**EAST LYME INLAND WETLANDS AGENCY  
SPECIAL MEETING MINUTES**

**May 18, 2020**

**A. Application of Harry Heller, Attorney/Agent for Pazz & Construction, LLC, Owner to conduct regulated activities in the upland review area in association with a proposed multi-family residential community on property identified in the application as N Bride Brook Rd, East Lyme Assessor's Map 09.0, Lot 37-2.**

**Re: Re: Inland Wetlands Application – North Bride Brook Multi-Family Development:**  
Application of Pazz & Construction, LLC; Jason Pazzaglia, Applicant; Pazz & Construction, LLC, Owner; to conduct regulated activities in the upland review area in association with a proposed multi-family residential community on property identified in the application as N Bride Brook Rd, East Lyme Assessor's Map 09.0, Lot 37-2.

EROSION & SEDIMENTATION CONTROL PLAN

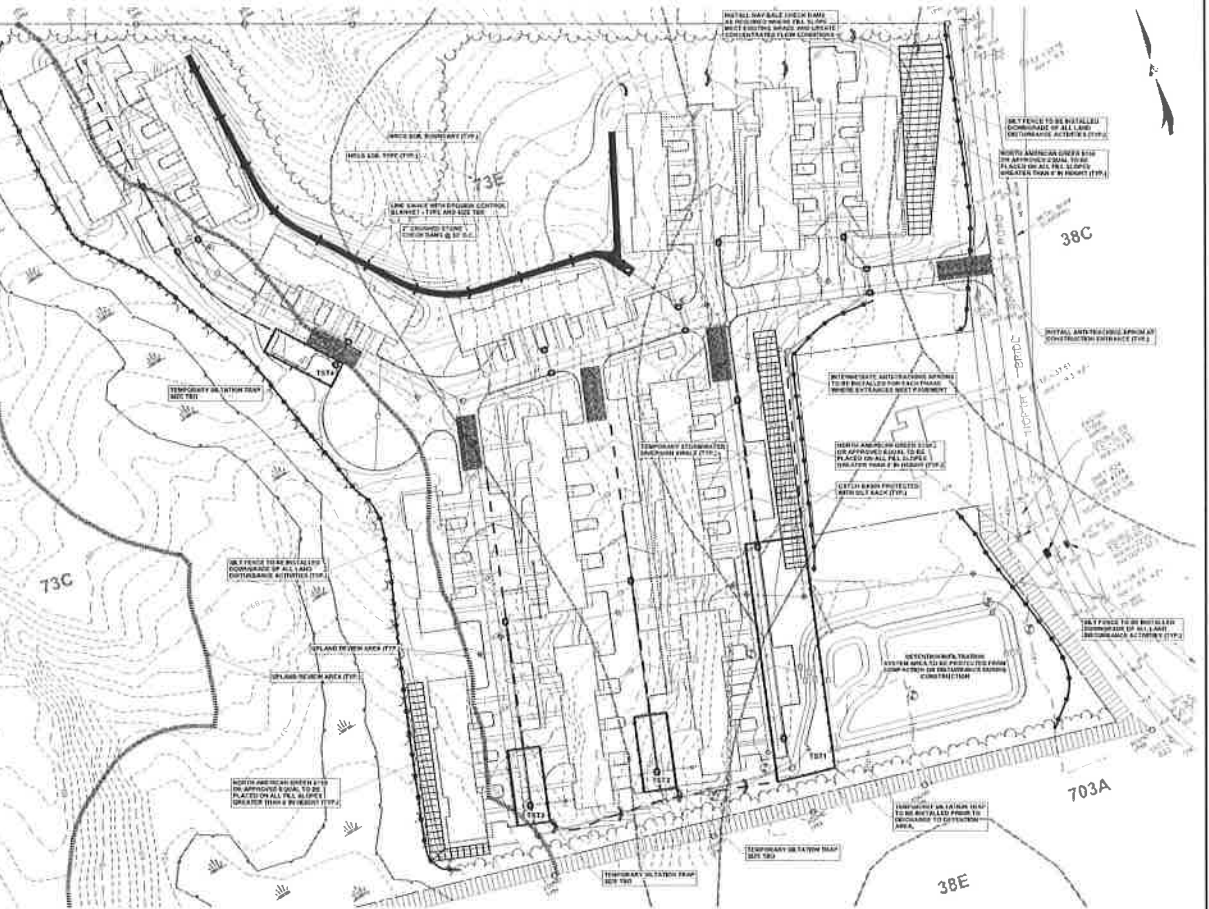
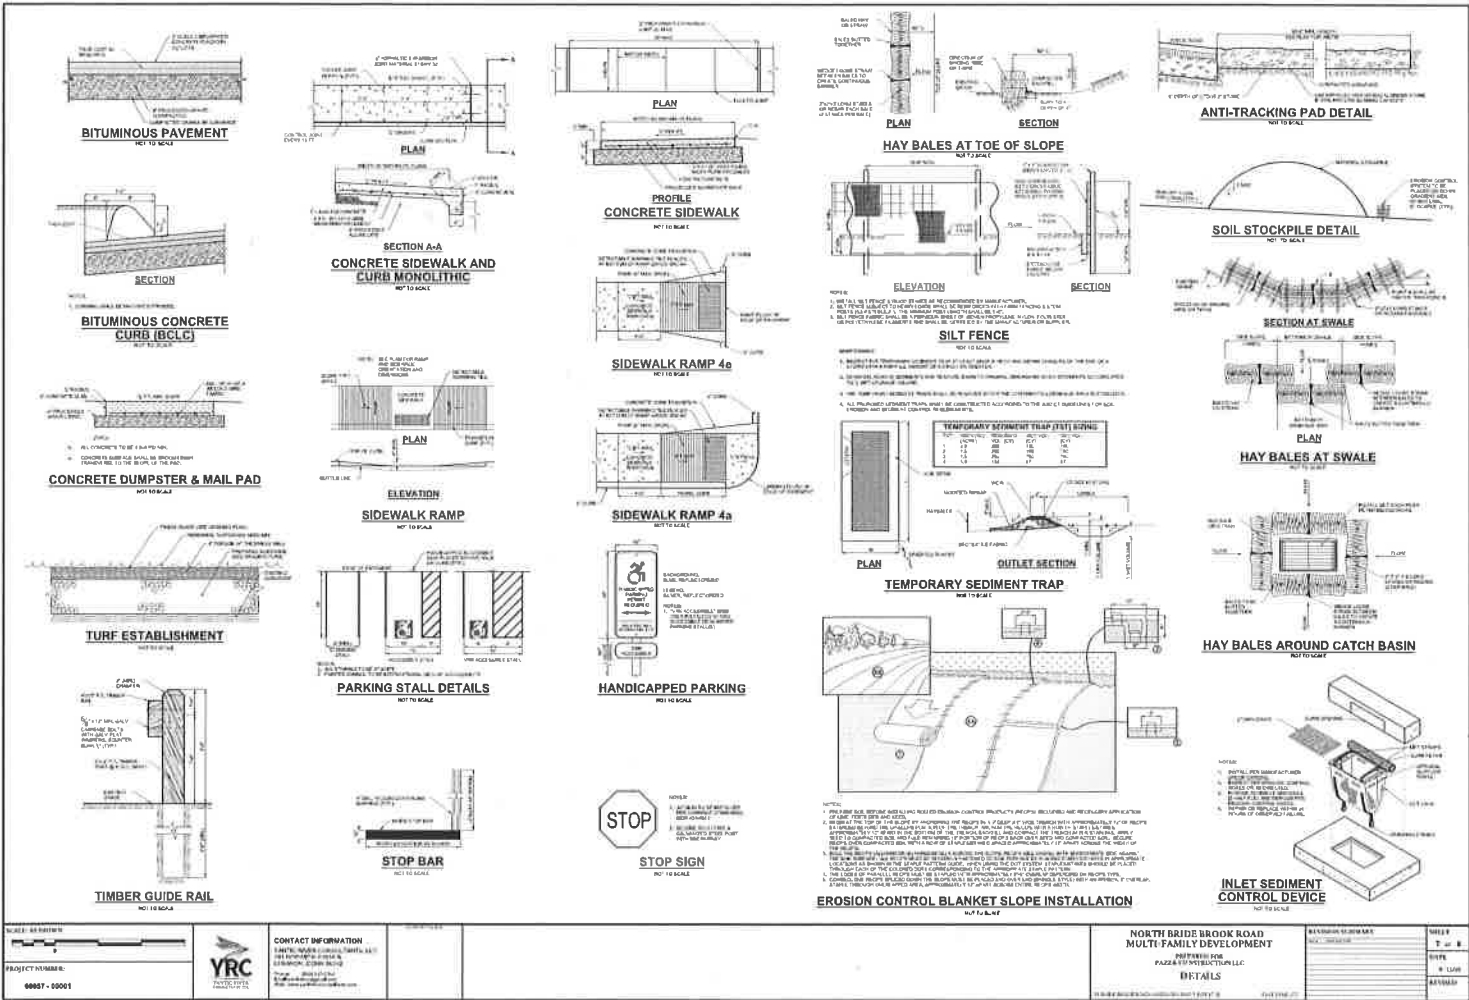
6. The Erosion & Sedimentation Control Plan (Sheet 5), and the Details (Sheets 6 & 7) are in compliance with the 2002 Connecticut Guidelines for Soil Erosion and Sediment Control. The Sequence of Construction and E&S Control Narrative notes on Sheet 5 propose that the project will be completed in multiple phases. Inspection and Maintenance notes along with Temporary Sediment Trap sizing and detail have also been included. Provide correction of numbering system for Drawing Set, Sheet Numbers 6 & 7.

6. The Erosion & Sediment Control Plan (Sheet 5), and the Details (Sheets 6 & 7) are in compliance with the 2002 Connecticut Guidelines for Soil Erosion and Sediment Control. The Sequence of Construction and E&S Control Narrative notes on Sheet 5 proposed that the

4. The Erosion & Sedimentation Control Plan (Sheet 5) and the Details (Sheets 6 & 7) provide compliance with the 2002 Connecticut Guidelines for Soil Erosion and Sediment Control. The Sequence of Construction and E&S Control Narrative notes (Sheet 5) propose that the project will be completed in multiple phases; Inspection and Maintenance notes along with Temporary Sediment Trap sizing and detail have also been included.
